Well Name: LA LEE ANN	Well Location: T27N / R13W / SEC 28 / NENW / 36.55129 / -108.22653	County or Parish/State: SAN JUAN / NM
Well Number: 2J	Type of Well: CONVENTIONAL GAS WELL	Allottee or Tribe Name:
Lease Number: NMNM37913	Unit or CA Name:	Unit or CA Number:
US Well Number: 300452558900C1	Operator: DUGAN PRODUCTION CORPORATION

Type of Submission: Notice of Intent Type of Action: Plug and Abandonment

Procedure Description: Dugan Production Corp. requests permission to plug and abandon the well per the attached procedure.

Attachment to notice of Intention to Abandon

Planned Wellbore P & A Schematic

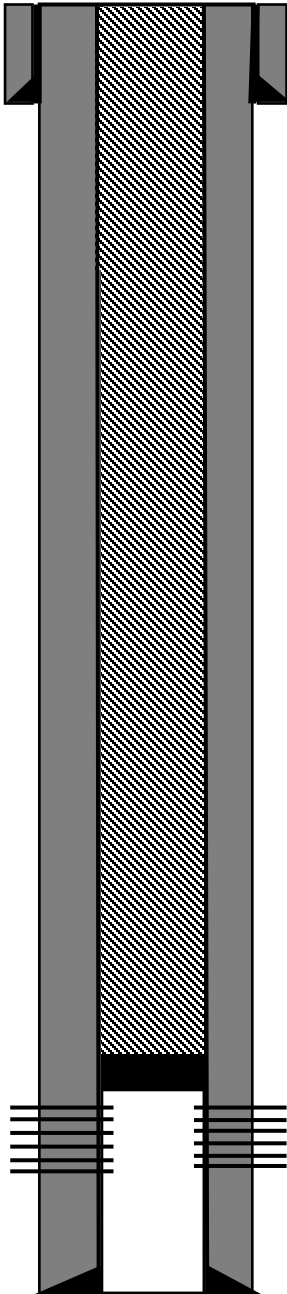
Complete wellbore fill up proposal. No changes to procedure.

Created By	Condition	Condition Date
mkuehling	Run cement to cover pc top at 1316 and 50 feet below - Notify NMOCD 24 hours prior to moving on - Monitor string pressures daily report on subsequent - submit all logs prior to subsequent.	9/5/2024
